OC DEVELOPMENT SERVICES REPORT

SUBJECT: Public Hearing on Planning Application PA20-0201 for a Coastal Development Permit, Use Permit and Variance

PROPOSAL: A request for a Coastal Development Permit, Use Permit and Variance approvals in conjunction with the demolition of an existing residence and construction of a three-level single-family residence with attached tandem garage.

LOCATION: The project is located within the community of Emerald Bay at 191 Emerald Bay, Laguna Beach, CA within the Fifth Supervisorial District. (APN 053-040-22)

SETBACK EXHIBIT

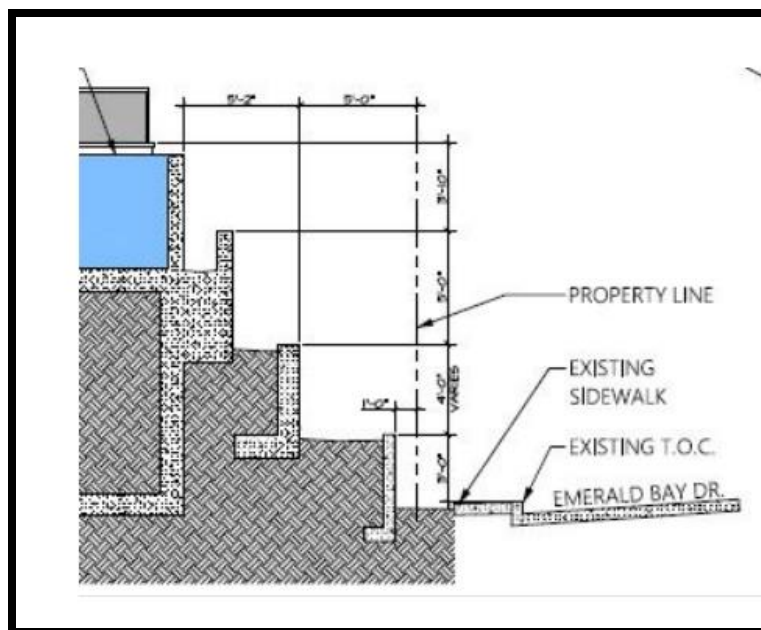
In this instance, the 15-foot minimum would be the applicable rear setback. One portion of the proposed residence would encroach to a minimum of 8 feet from the northerly property line.

Staff finds that the special circumstances relating to the property include its shape, its sloping topography, and its location in a coastal community with strict architectural guidelines. All of these are unique aspects to the subject lot and vicinity when compared to other R1 zoned properties within the County.

OVER-HEIGHT STRUCTURE EXHIBIT

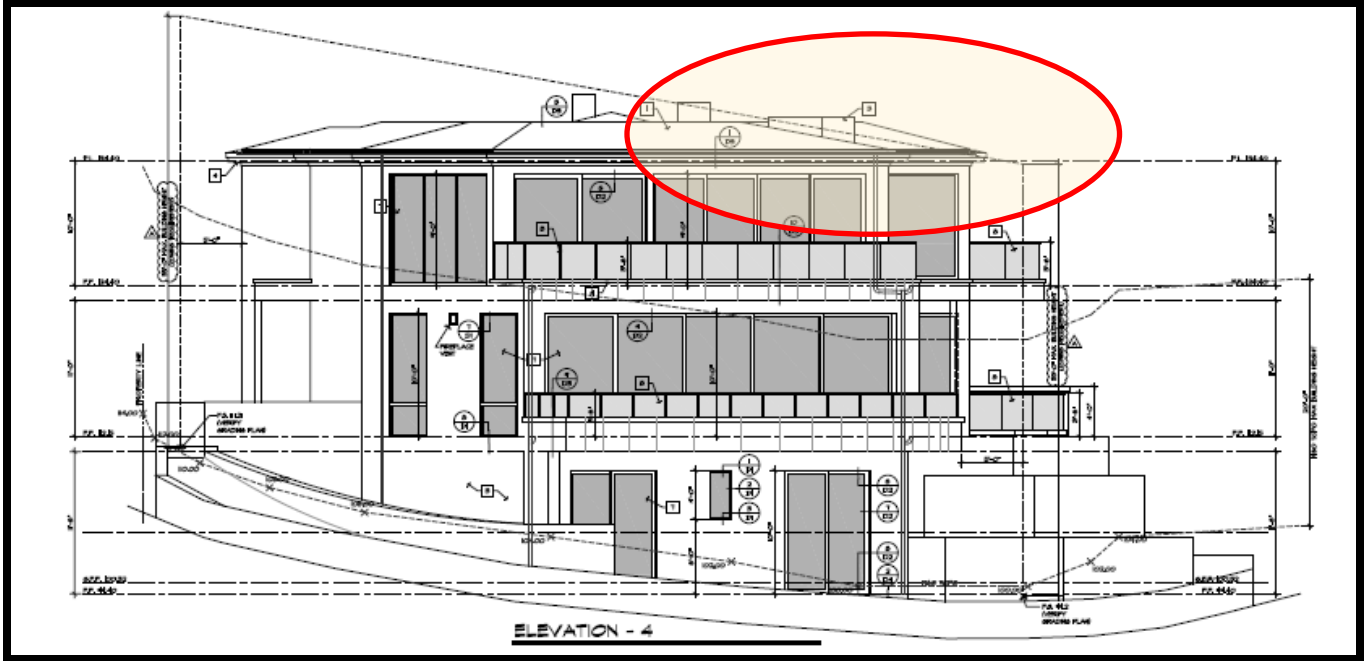
The project plans include proposed elevations that depict the maximum building envelope in a manner consistent with the Zoning Code's prescribed method. Due to the slope of the site, there is a small projection of the roof area that exceeds the 35-foot maximum height. This area is a continuation of the architectural style of the residence and provides no additional sleeping or eating areas for the home.

(1) Towers, gables, spires, flagpoles, and architectural features not for sleeping or eating quarters or for any commercial purpose may exceed the district building height limit by ten (10) feet subject to a Use Permit approved by the Zoning Administrator per section 7-9-125.
